SUBJECT: ISSUANCE OF AMENDMENT NO. 168 TO FACILITY OPERATING LICENSE
NO. DPR-62 - BRUNSWICK STEAM ELECTRIC PLANT, UNIT 2, REGARDING
MAXIMUM EXPANDED OF OPERATING DOMAIN (TAC NO. 72853)

AMENDMENT TO FACILITY OPERATING LICENSE

Amendment No. 168
License No. DPR-62

ATTACHMENT TO LICENSE AMENDMENT NO. 168

Figure 2.2.1-1. APRM Flow Bias Scram Relationship to Normal Operating Conditions

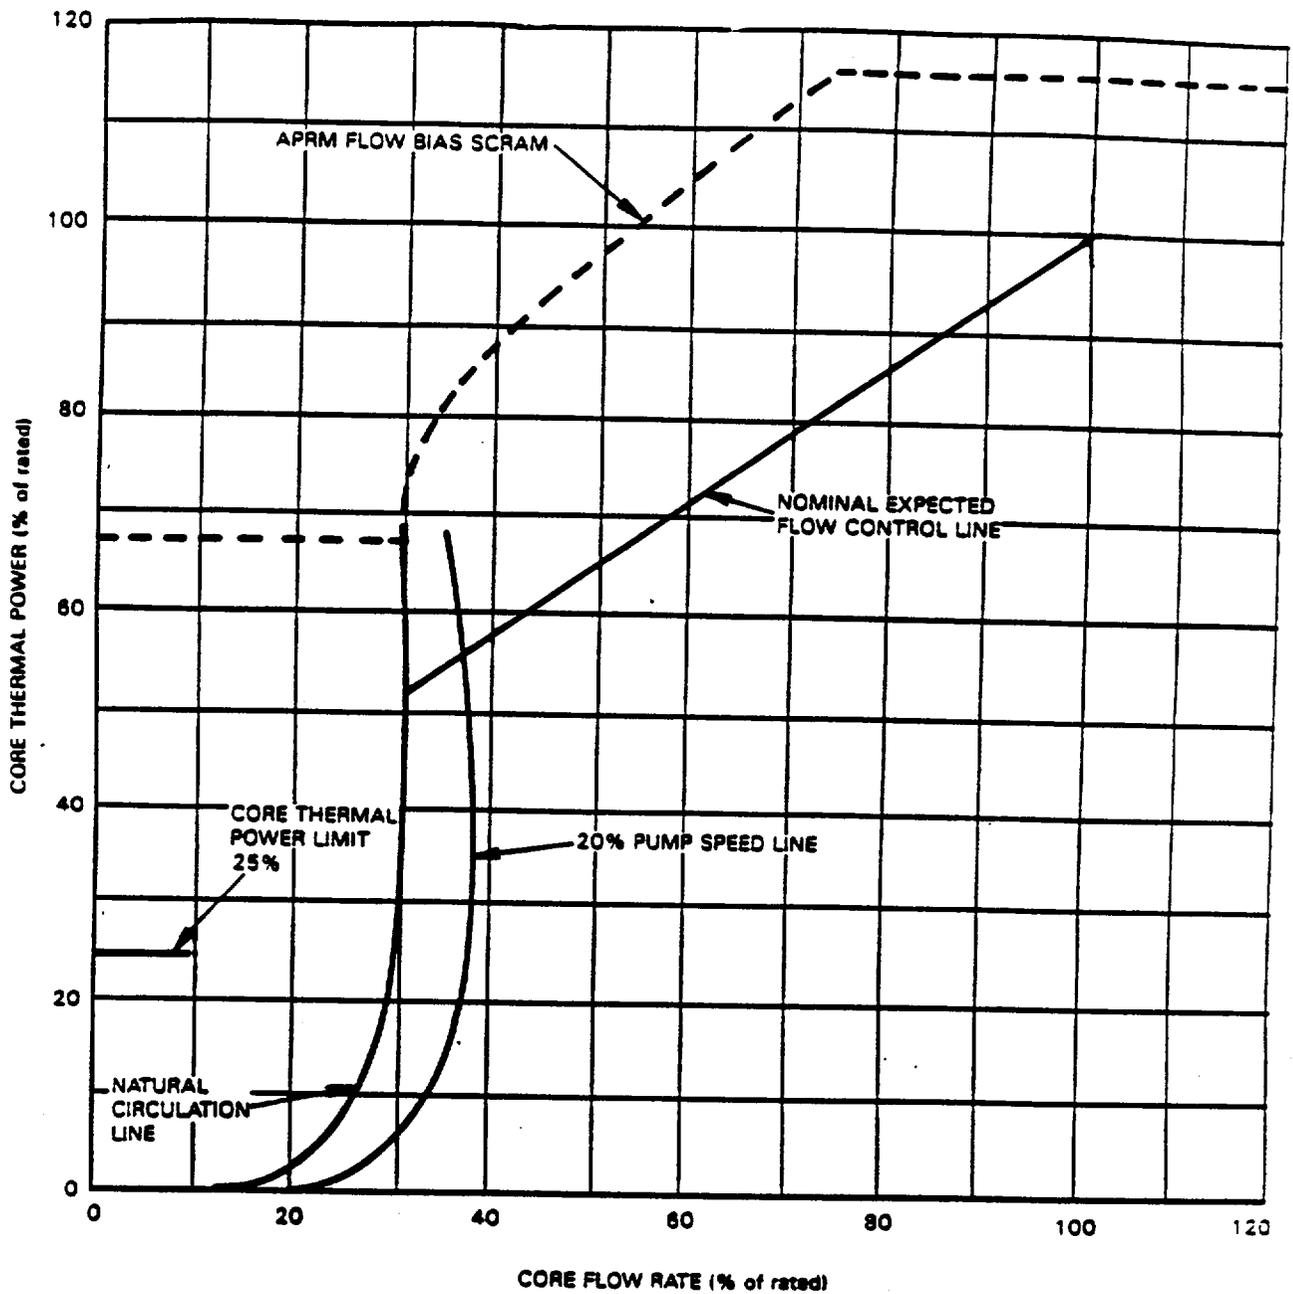
The MEOD proposal changes the APRM flux scram lines on the power/flow map and permits operation up to the new APRM flux scram line ($0.66W + 64$ percent) and up to the intersection with the 100 percent power line occurring at a flow of 75 percent. This is a standard change for MELLL. For ICF, the proposed flow increase is to 105 percent core flow at 100 percent power with a linear expansion to 110 percent core flow at 70 percent power. The increased flow would be allowed throughout a plant cycle. The flow-biased rod block trip equation is changed to $0.66W + 58$ percent with a maximum value of 108 percent. The maximum value of 108 percent necessitates a modification to establish a clamping function for the rod block trip level (see Section 2.5).

- (b) This Average Power Range Monitor scram function is a fixed point and is increased when the reactor mode switch is placed in the Run position.
- (c) The Average Power Range Monitor scram function is varied, Figure 2.2.1-1, as a function of the fraction of rated recirculation loop flow (W) in percent.
